# Consultation Report

### A160/A180 Port of Immingham Improvement

<b>Planning Act 2008</b>	
<b>Infrastructure Planning (Applications: Prescribed Forms and Procedure) Regulations 2009</b>	
<b>Regulation Number:</b>	Planning Act 2008, Section 37(c) and 37(7)
<b>Author:</b>	Highways Agency & Jacobs
<b>Document Reference:</b>	TR010007/APP/8a

Figure 6: Overview of changes to proposals following consultation

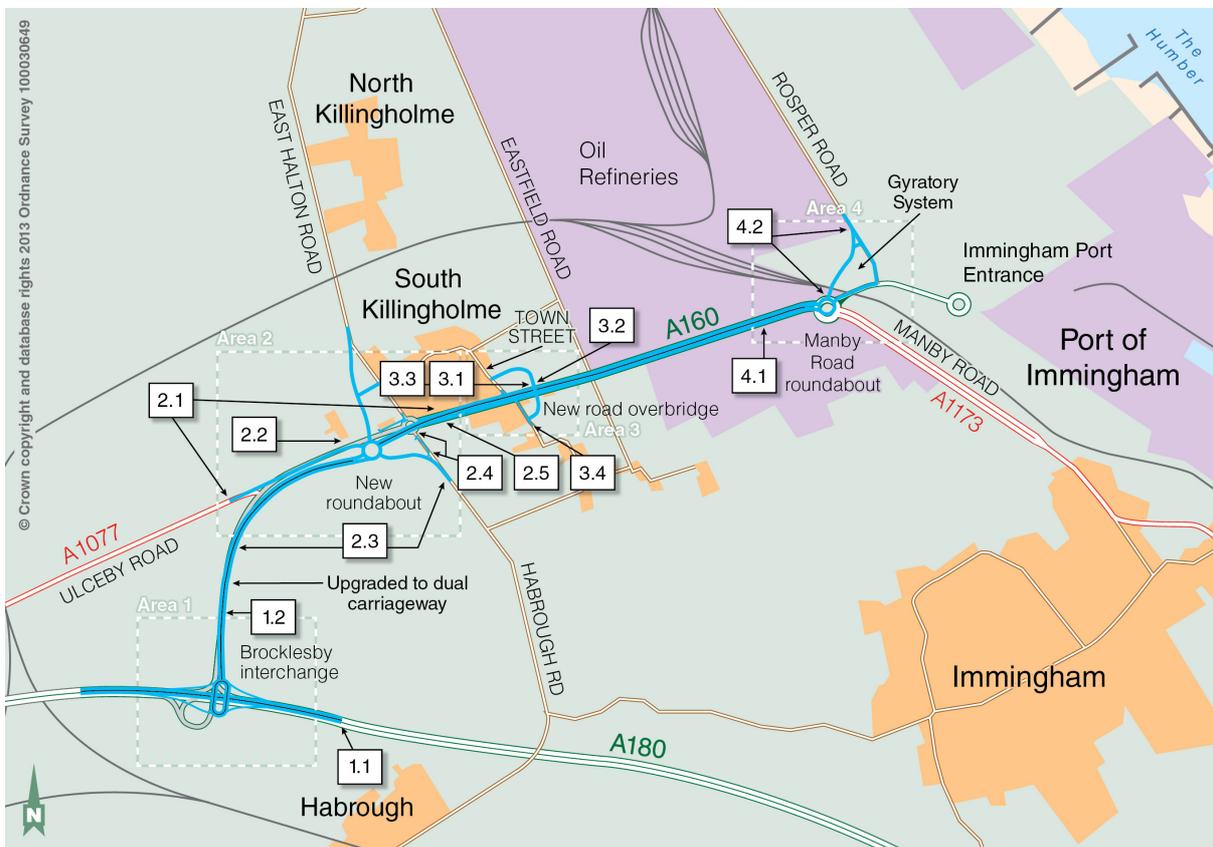
- 5.1.1 Feedback received clearly demonstrates that there is overall support for the proposed improvements, with 90% of questionnaire respondents agreeing with the overall proposal. Positive comments especially revolved around improved road safety and access.
- 5.1.2 There were also some notable issues which have been taken into account and addressed where possible. The most commonly mentioned issues related to access for non-motorised users, traffic flow and impacts on neighbouring villages.
- 5.1.3 The main changes made to the Project proposals as a result of the comments received during consultation are shown on Figure 6 and listed below:
